#### Regulation No. 37 (Filament lamps)

## **Proposal for Supplement 41 to the 03 series of amendments to Regulation No. 37 (Filament lamps)**

### **Submitted by the expert from the Working Party "Brussels 1952"\***

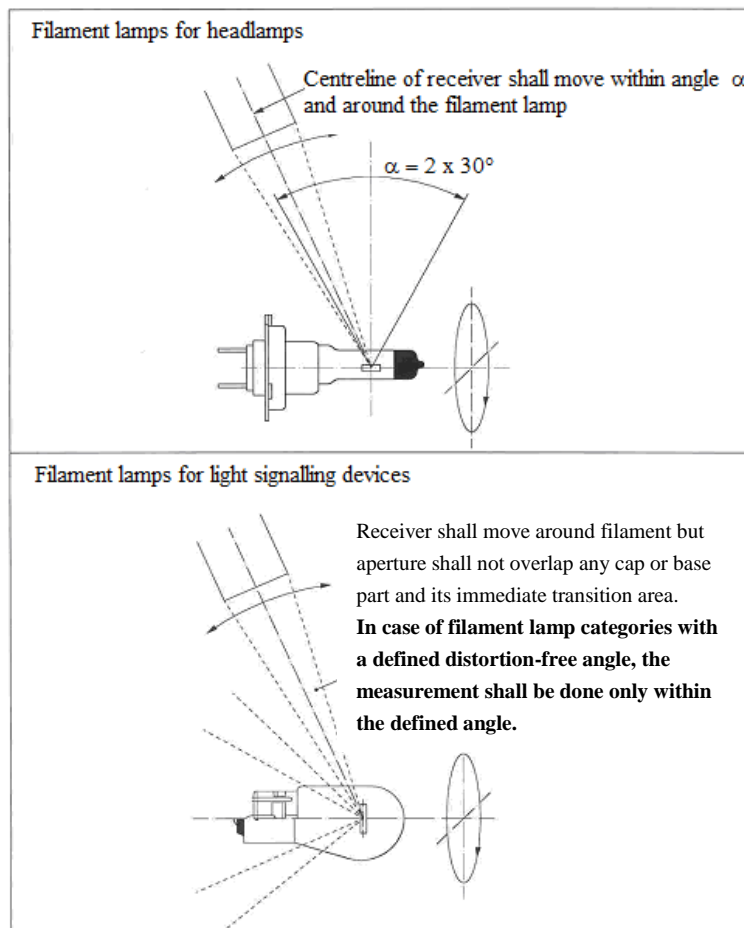
Paragraph 2.3.3., amend to read:

"2.3.3. For filament lamps used in light signalling devices, measurements shall be made in directions around the filament lamp with exception of:

- (a) The area claimed or covered by the cap of the filament lamp; and
- (b) The immediate transition area along the cap.

In case of filament lamps with two filaments, the centre of the major filament shall be taken.

**In case of filament lamp categories with a defined distortion-free angle, the measurement shall be done only within the defined angle."**

The figure illustrating the positions of colorimetric receiver, the text in the lower part, amend to read:
